## SERVICE BULLETIN

**APPLICABILITY:** 2019-21MY Impreza  
 2019-21MY Crosstrek (Including Hybrid Model)  
 2019-21MY Forester  
 2019MY Legacy/ Outback  
 2019-21MY WRX  
 2019-20MY BRZ- Navigation -equipped ONLY  
 2019-21MY Ascent

**NUMBER:** 15-236-18R

**SUBJECT:** Reprogramming File Availability for Optimization of Harman Gen 3.1 and Gen 3.1α Audio and Navigation Head Units

**NOTE 4:** Displaying Repair Facility POI icons:

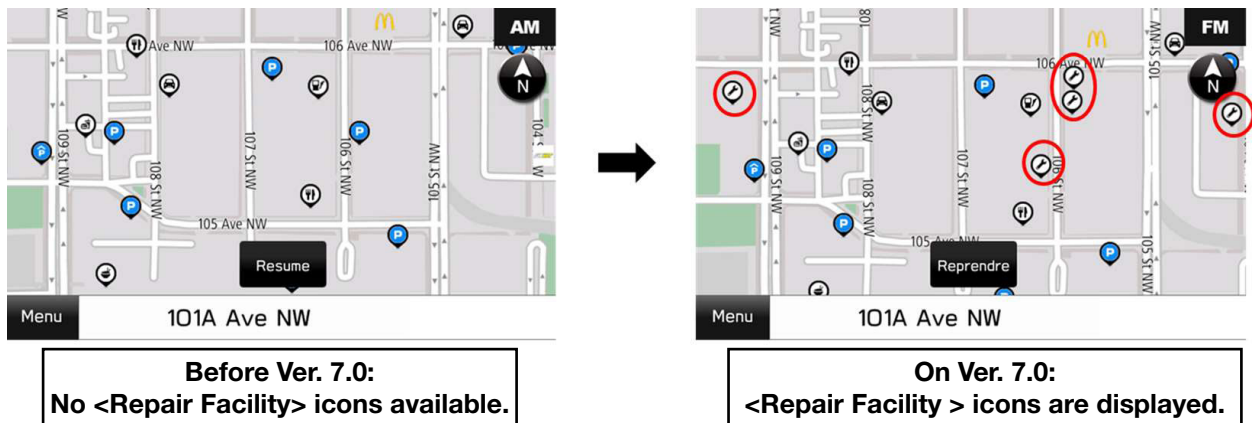
- 7) When an iPhone (CarPlay allowed) is connected using USB, the system moves to CarPlay screen no matter what is set in the <Auto Show Connected Device> menu in Setting. The Setting menu of <Auto Show Connected Device> is applicable only on Android Auto. See **NOTE 3** below.
- 8) Repair Facility POI icons are now shown on the NAVI map display. See **NOTE 4** below.

<Repair Facility> Icons can be displayed in the NAVI Map.

<Repair Facility> Icons can be turned On or OFF by going to: Settings > Navigation > POI Icons.

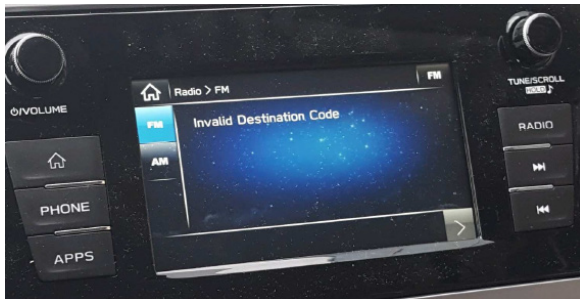
<Scan> previously displayed on SXM screen was changed to <Tune Scan> (a.k.a. SEEK).
